RE: Addendum No. 1 to the Bidding Documents for:
RIVERTON HVAC & POOL REPAIRS

RE: Addendum No. 2 to the Bidding Documents for:
RIVERTON HVAC & POOL REPAIRS

RIVERTON HVAC AND POOL REPAIRS

RIVERTON ELEMENTARY SCHOOL

ELEVATIONS AND ROOF PLANS
RIVERTON HVAC AND POOL REPAIRS
RIVERTON ELEMENTARY SCHOOL
PORTLAND, MAINE

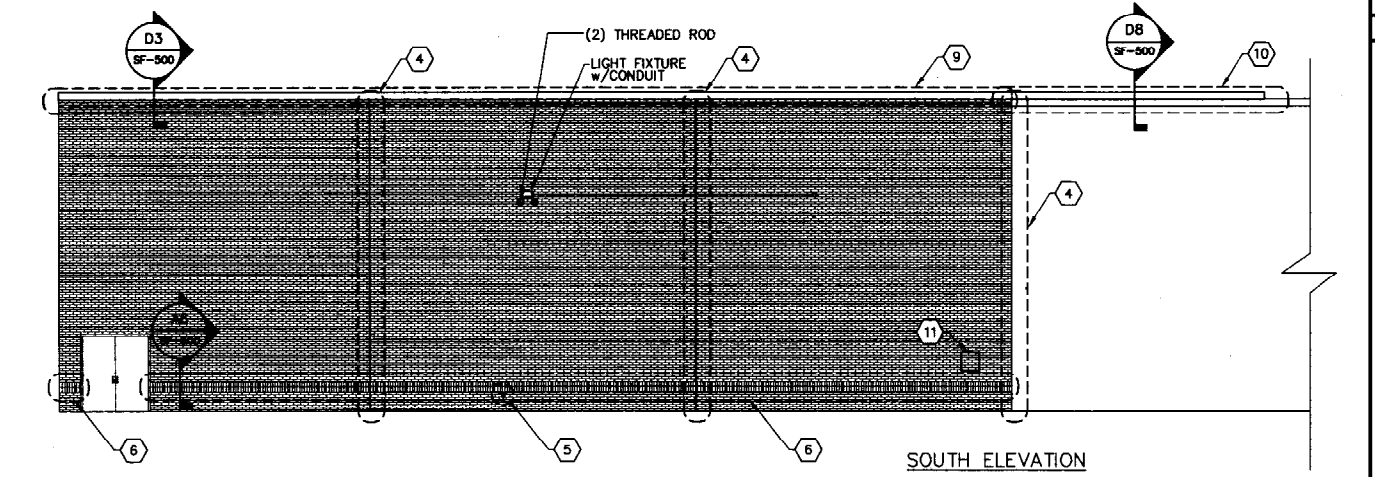
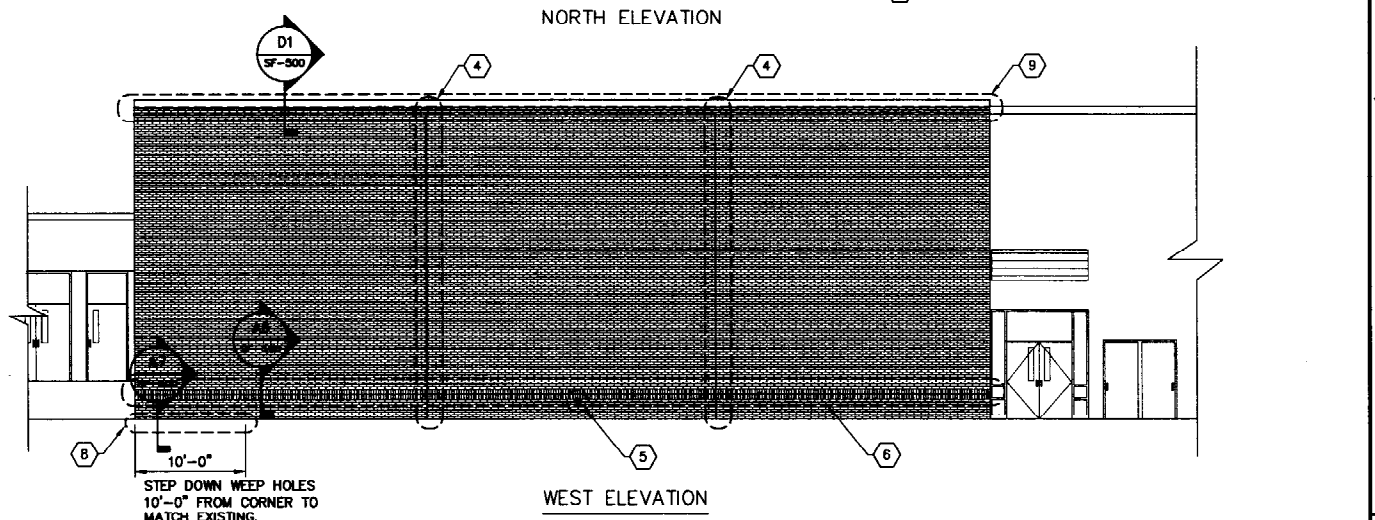
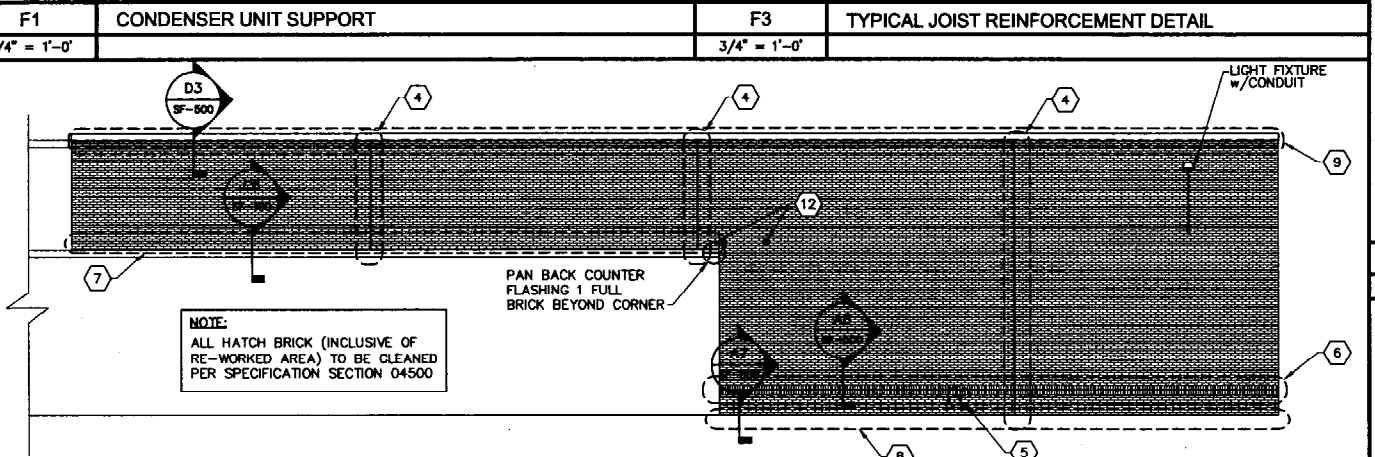
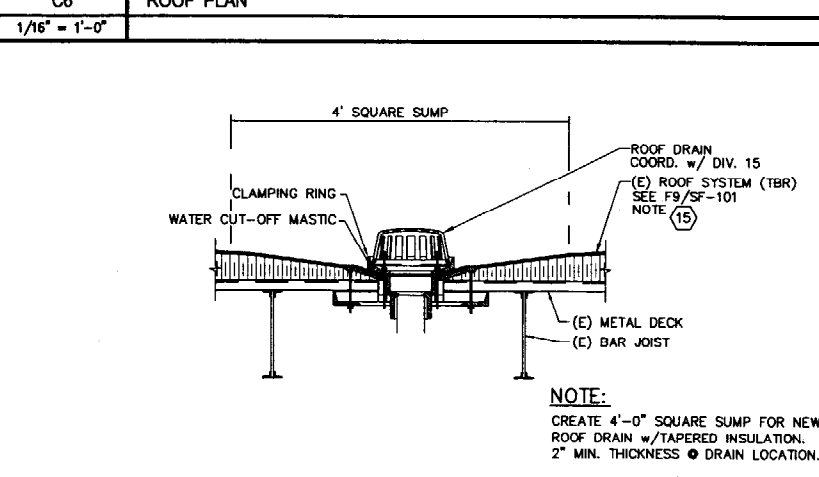
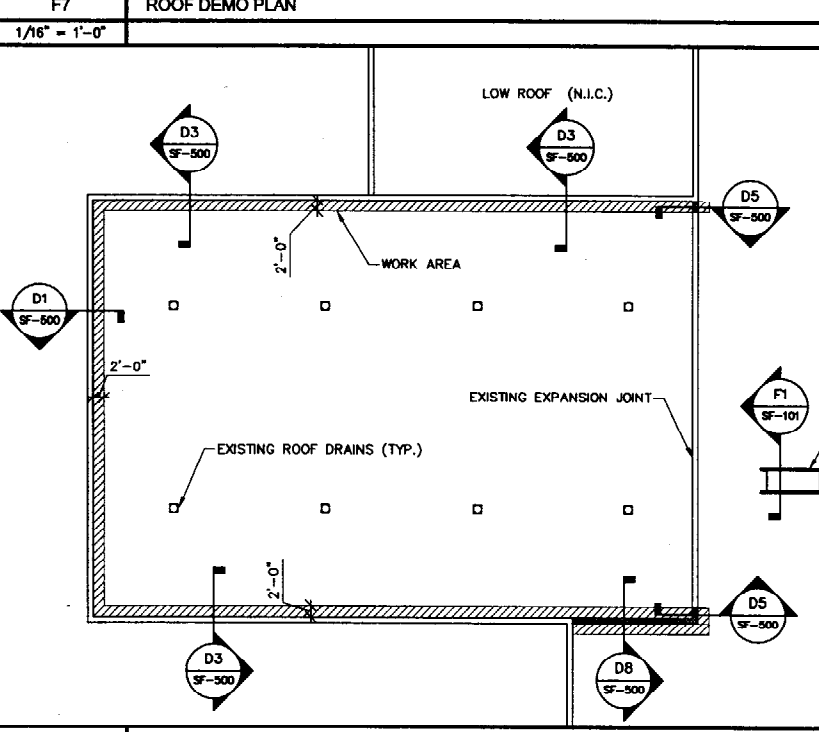
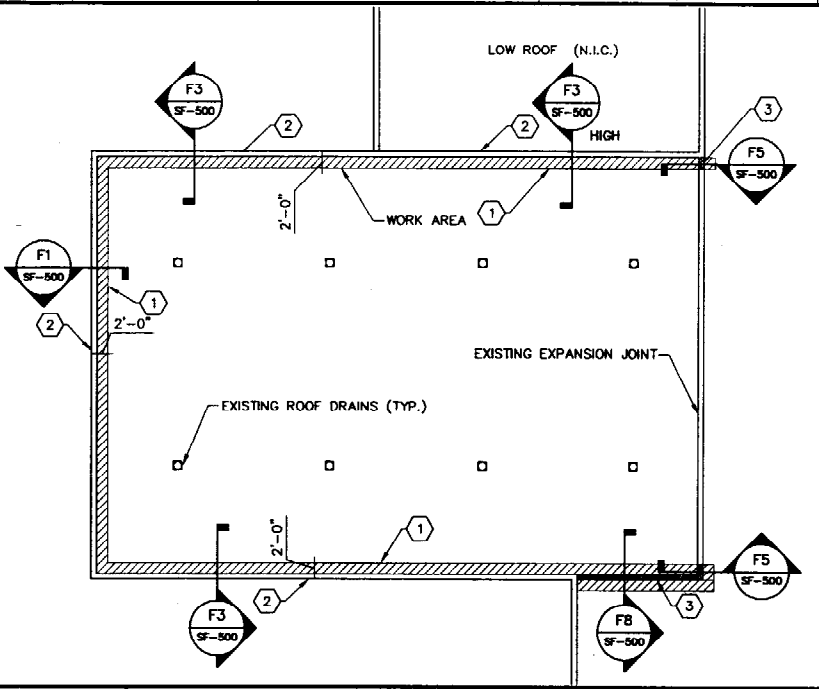
Delete: Detail A1 – Exterior Elevations, North Elevation, Section Symbol C6 on SF-100.

Add: in its place Section A9 on Sheet SF-500 and reverse direction of cut reference.
